From: District of Columbia Office of Disability Rights
Alexis Taylor, Director
Anwar Mahmood, Architect

Re: Accessibility Survey Report:
IN3-At Howard University
2301 Georgia Ave. NW
Suite D
Washington, DC

Date: April 11, 2017

**Figure 307.4
Vertical Clearance**

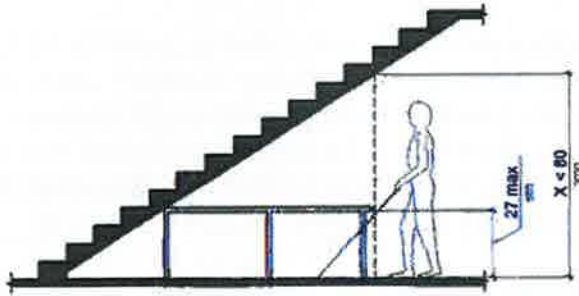
- **ISSUE(S): Yellow Staircases:** Both staircases are not ADA compliant for the following reasons:
 1. The lack of handrail extensions.
 2. The top landing on the front staircase has sloped surface (8.7%).
 3. The underside of both staircases is unprotected and hazardous for a white cane user due to vertical clearance requirements.

SOLUTION(S): *Please refer to 2010 ADA Standards by DOJ Section 307.4, 504 and 505.* For Stairways and handrails modifications.
